RE: RESPONSE TO INFORMATION REQUEST IN RELATION TO THE DEVELOPMENT APPLICATION FOR A DEVELOPMENT PERMIT FOR THE MATERIAL CHANGE OF USE (DUAL OCCUPANCY) AND RECONFIGURATION OF A LOT (1 LOT INTO 2 LOTS) OVER LAND AT 36 WARNER STREET, PORT DOUGLAS, MORE FORMALLY DESCRIBED AS LOT 416 ON RP907333

COUNCIL REF: CA 2025_5837/1 (Doc ID:1324821)

Landscape planting plan - ground floor 1:100 @ A1

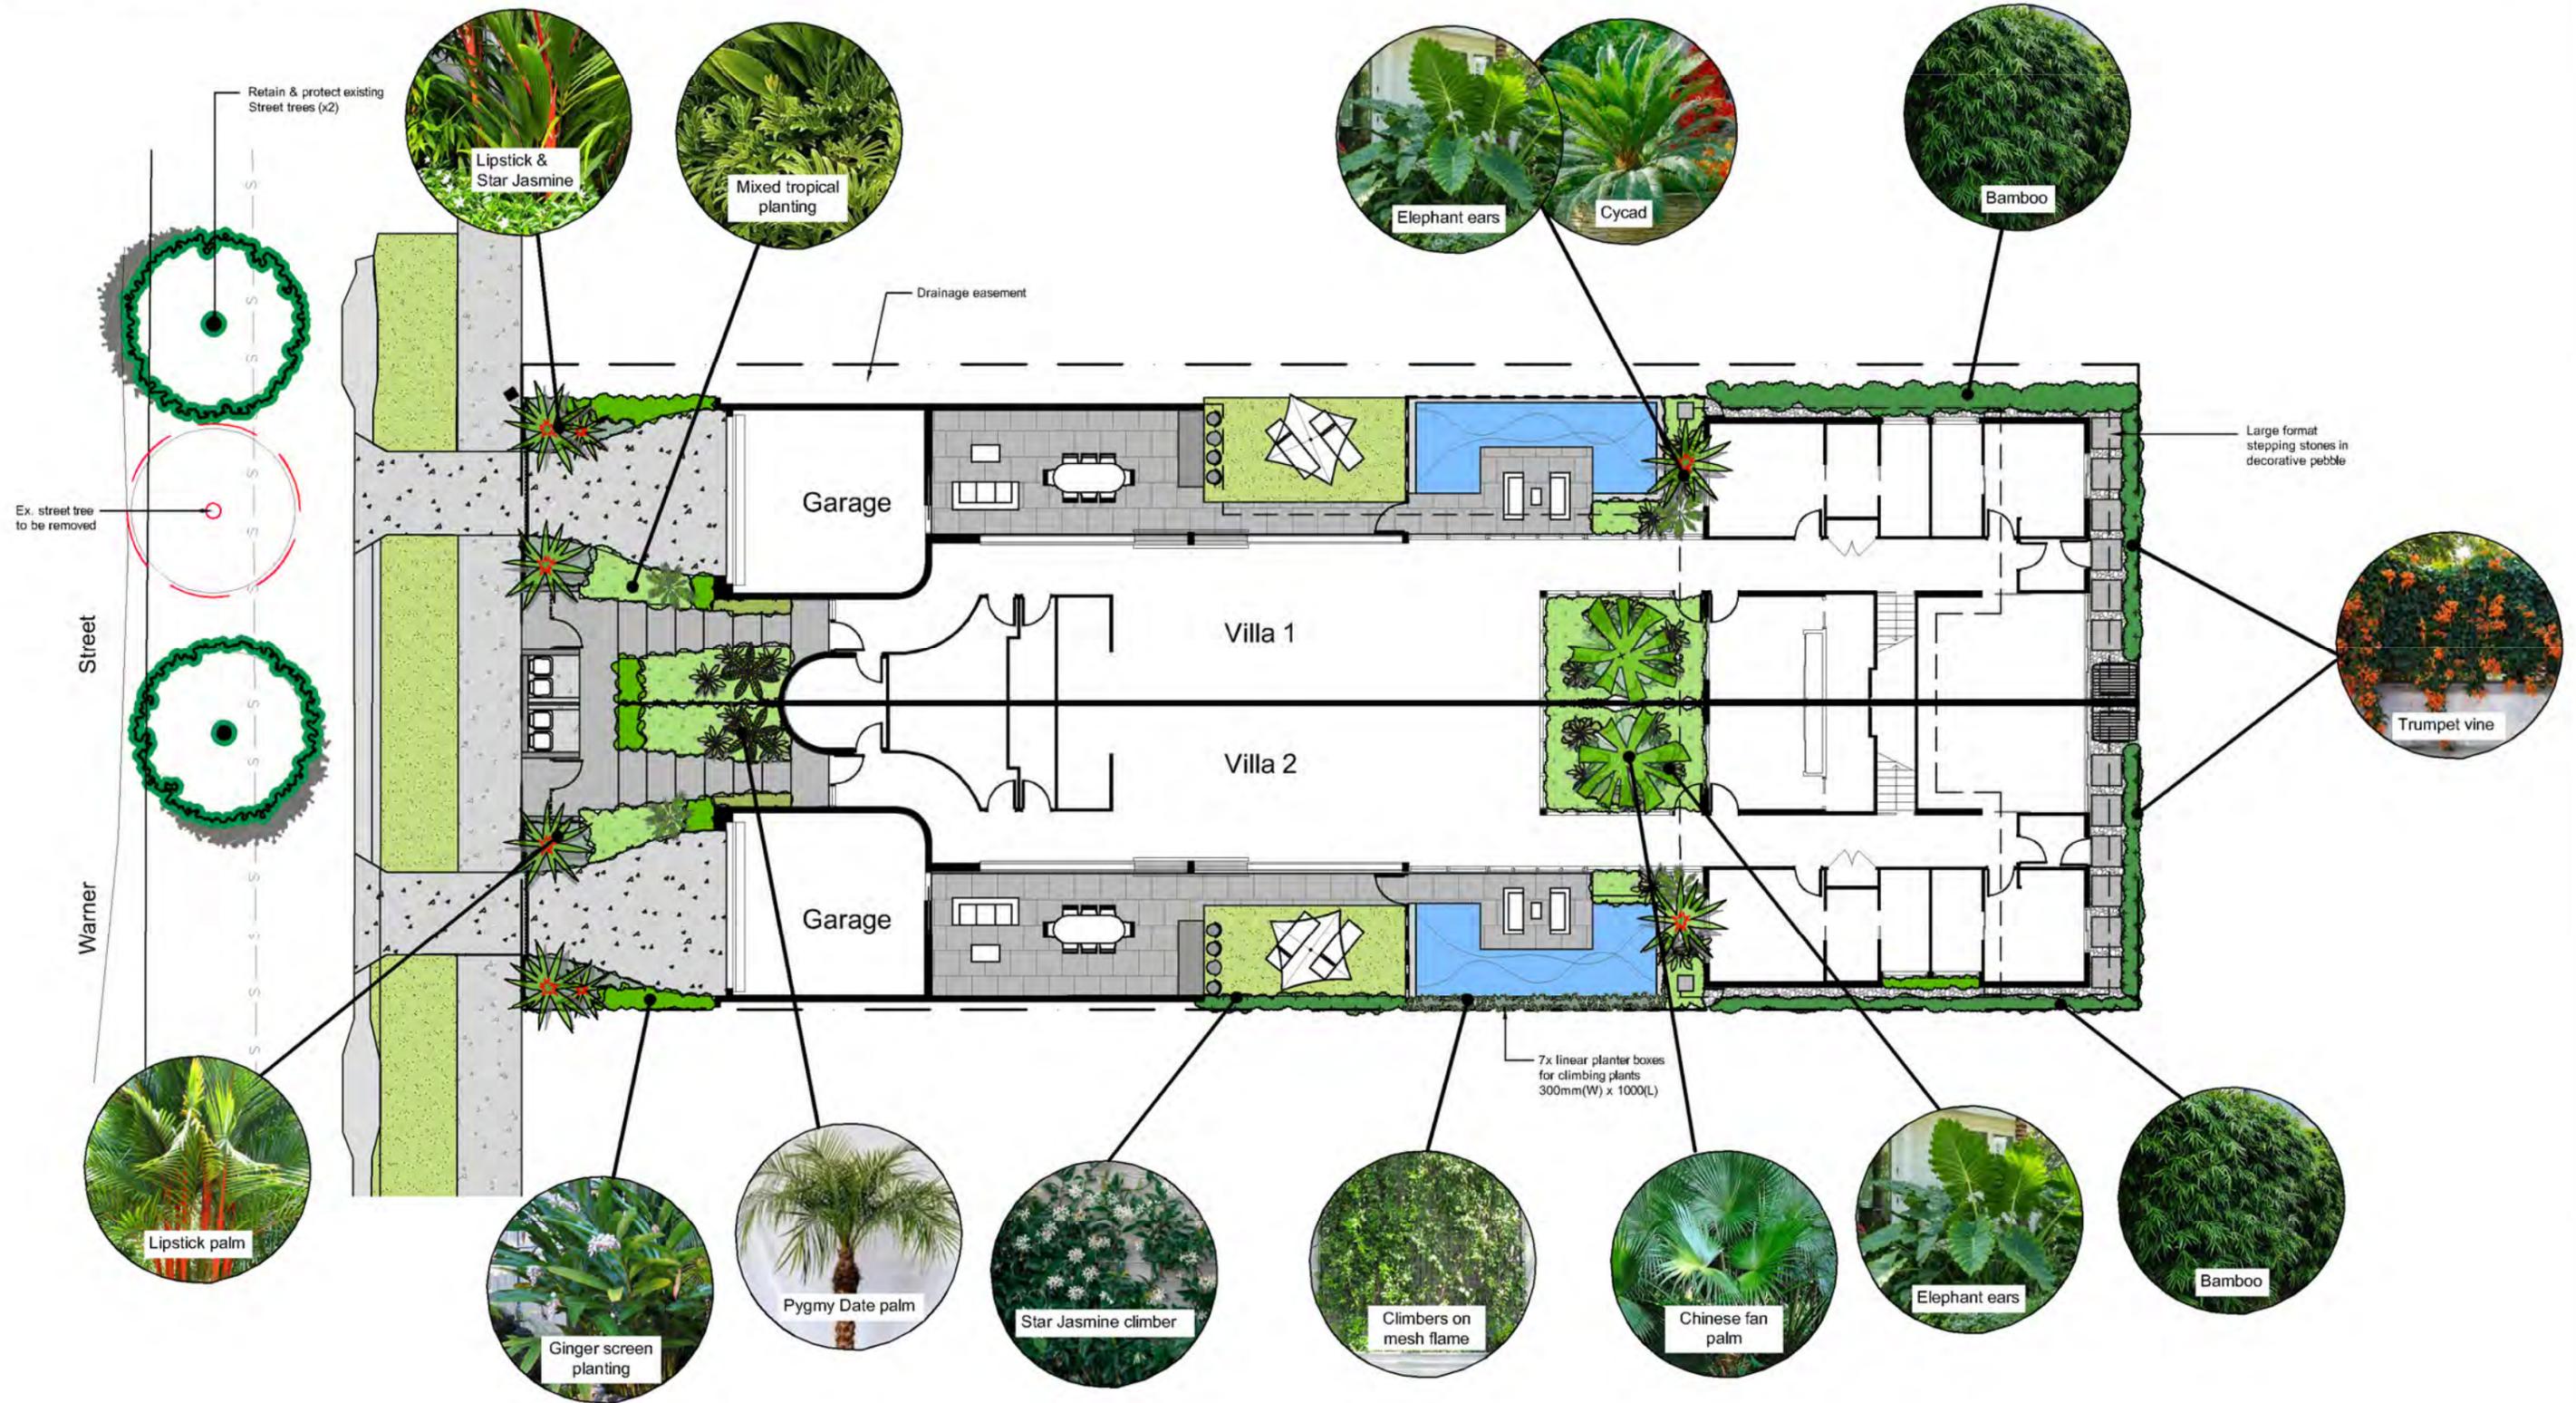
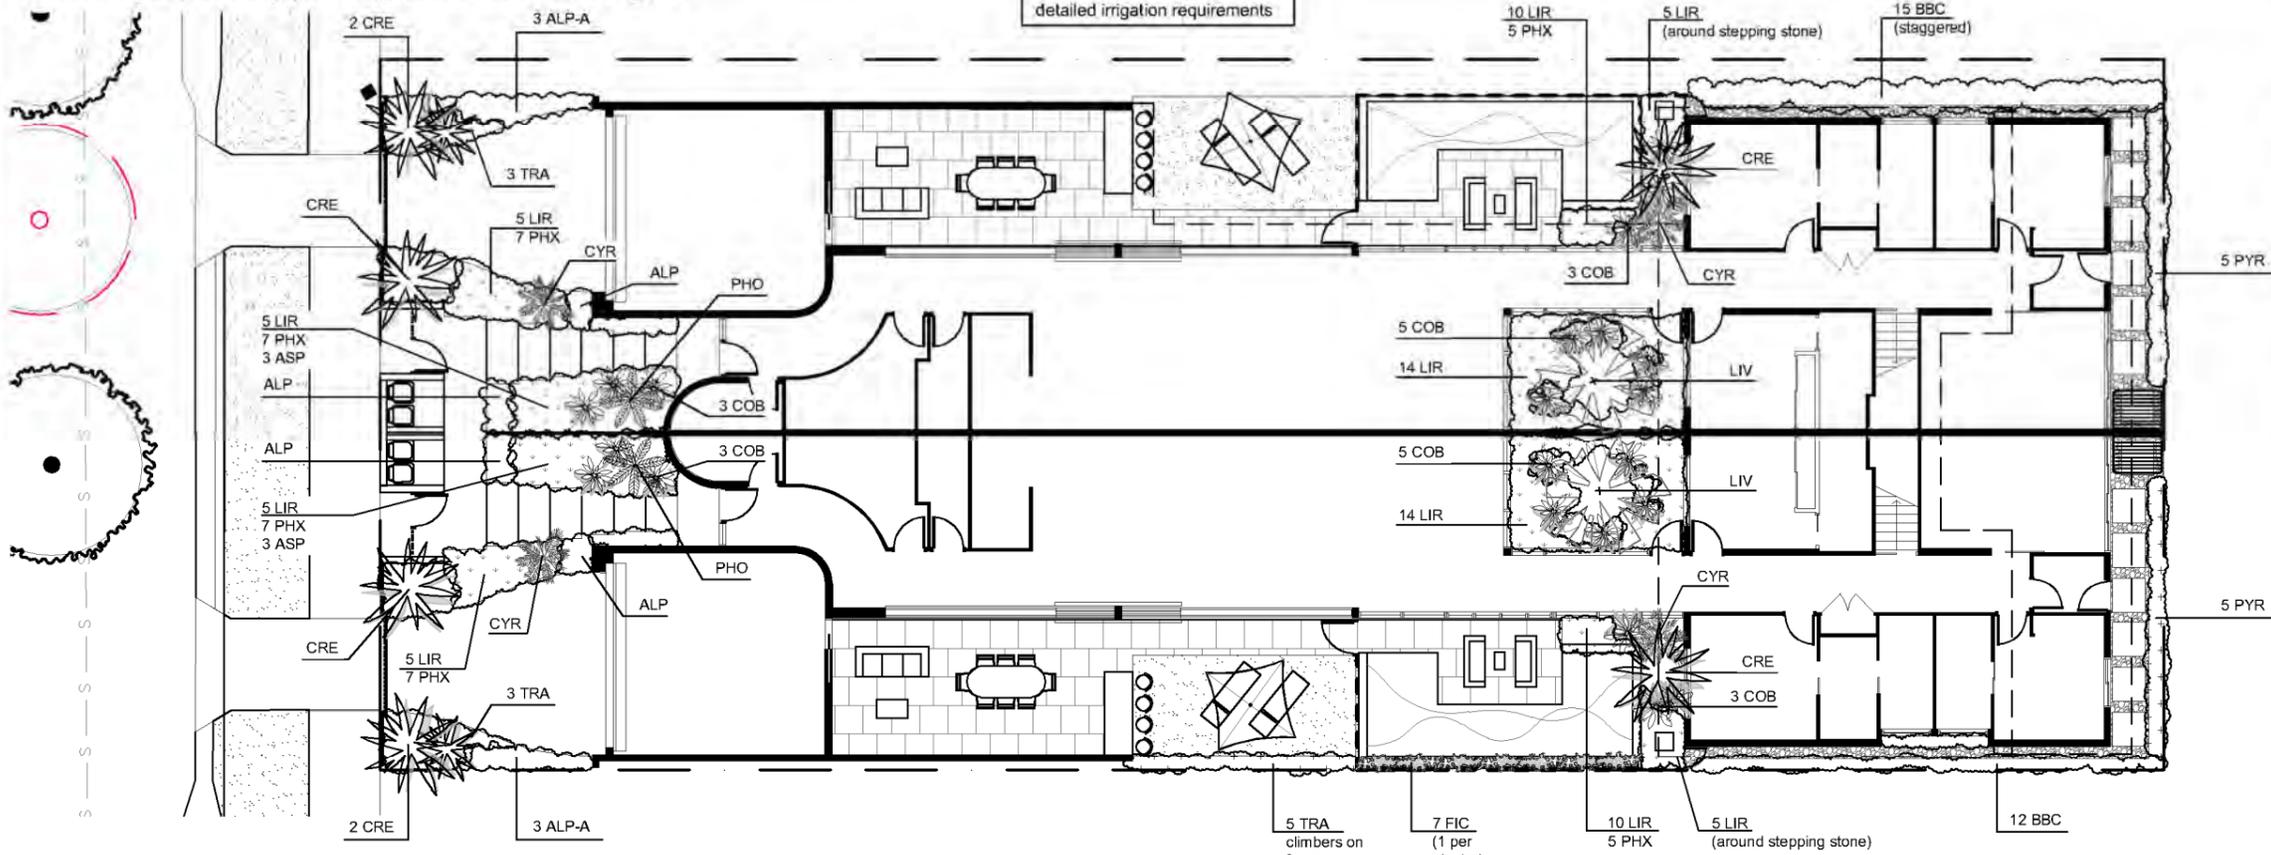
Landscaping is an integral part of the development to ensure a resultant tropical design. There are opportunities for trees in the front of each villa. Please provide a detailed landscape plan that incorporates tropical design and meets the Planning Scheme outcomes.

Please refer to the Landscape Plan prepared by Kate Hewitt Landscape Design included under Attachment 3. The design include a mix of tropical planting in line with the existing character of Port Douglas and Planning Scheme requirements.
